SERVICE BULLETIN # 00002

SUBJECT: Anti-Tip Shim

MODELS: Electro-Mechanical, Merlin 2000, Merlin III

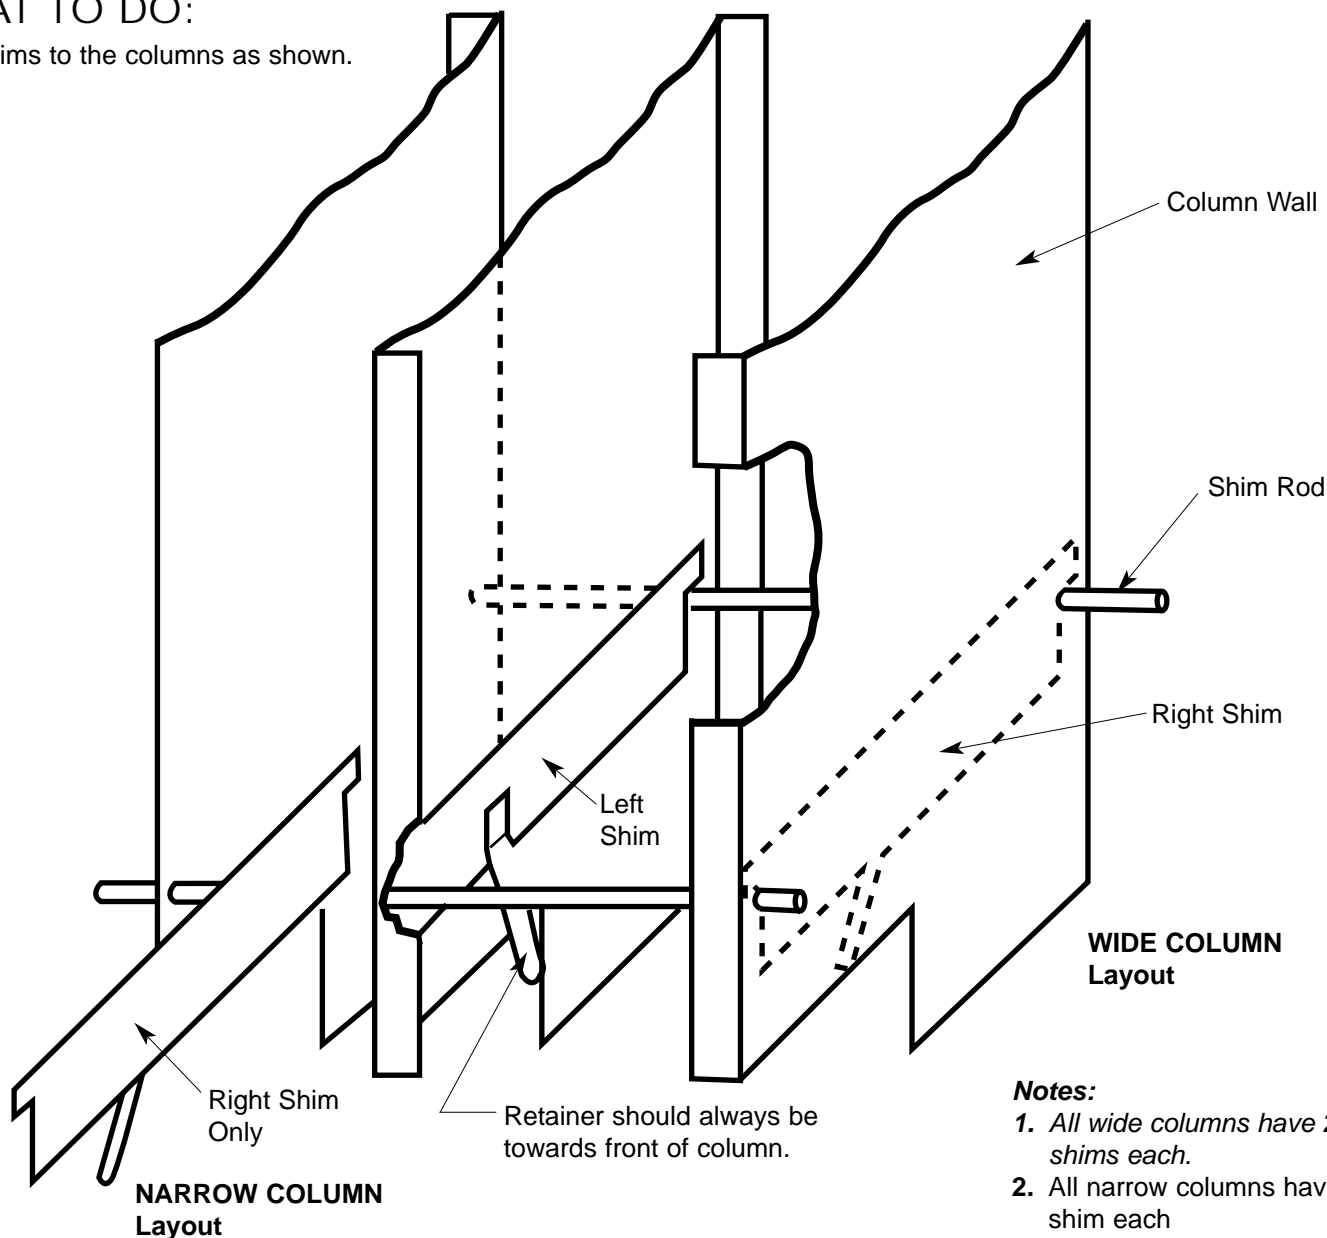
REASON FOR Bulletin:

To keep the rear can from being moved forward by rocking the vender to obtain a free can.

Add Shims to the columns as shown.

- Notes:**
1. All wide columns have 2 shims each.
 2. All narrow columns have 1 shim each
